LIBERATOR FAIRING HANDLEBAR MOUNTING BOLTS / FL, FLH

All Harley-Davidson dealers were notified by Service Letter dated January 27, 1975 that an insecure assembly resulted from using 3 inch long handlebar mounting bolts, supplied with the Liberator Fairing, on 1972 and earlier FL/FLH models. The 3 inch bolts are satisfactory for use only on 1973 and later models.

SUPPORT BRACKET ALTERATION FOR
1972 & EARLIER MODELS

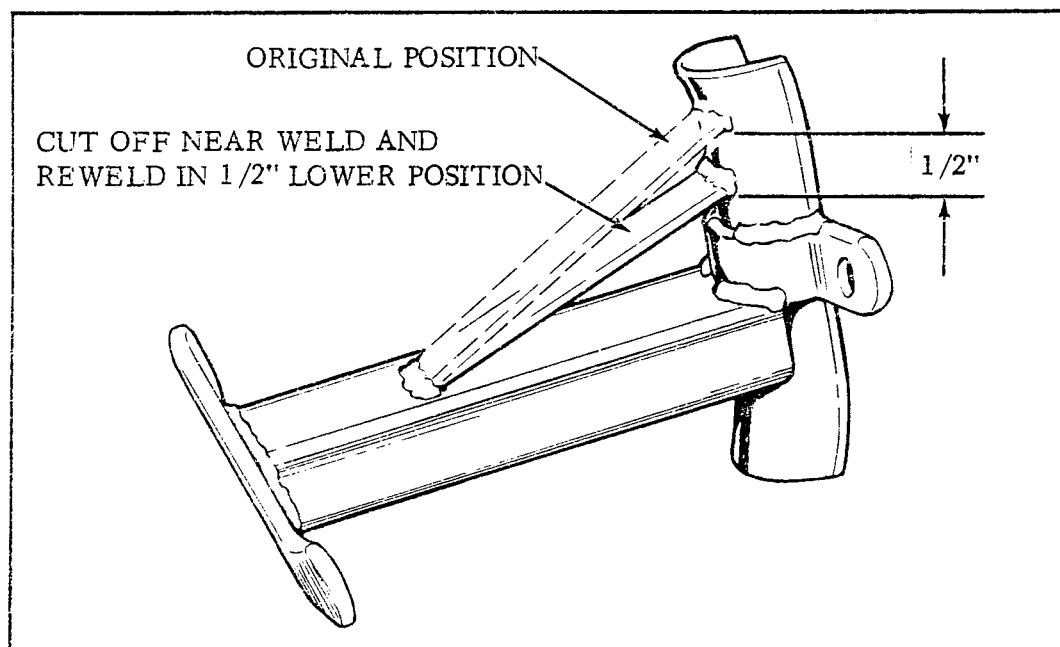
NOTE: When installing any Liberator Fairing on 1972 and earlier models, the fairing support reinforcement strap should be checked for interference with the handlebar mounting bolts when handlebars are turned to left and right fork stop positions. To obtain necessary clearance, cut approximately 1/4 inch off frame head end of strap and re-weld in the lower position as shown in the illustration.
